**Economic Commission for Europe****Inland Transport Committee****World Forum for Harmonization of Vehicle Regulations****Working Party on Passive Safety****Fifty-third session**

**Regulation No. 44 (Child restraints systems)****Draft Supplement 8 to Regulation No. 44****Submitted by the expert from Japan\***

**Validation test of load application device I for Group 1**

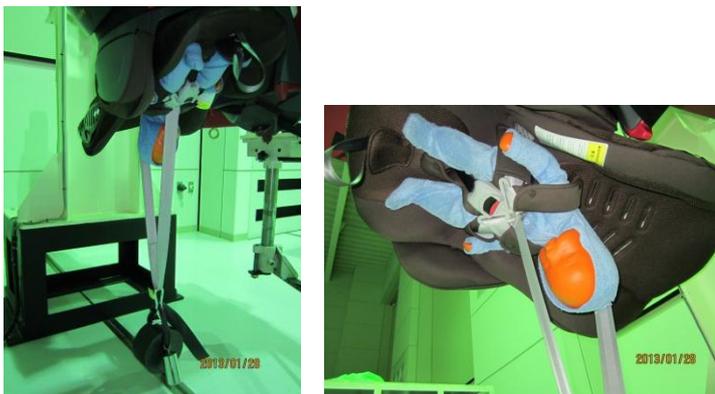
Although some interference between the device and the harness was observed, we have concluded that such interference would not affect the test result.
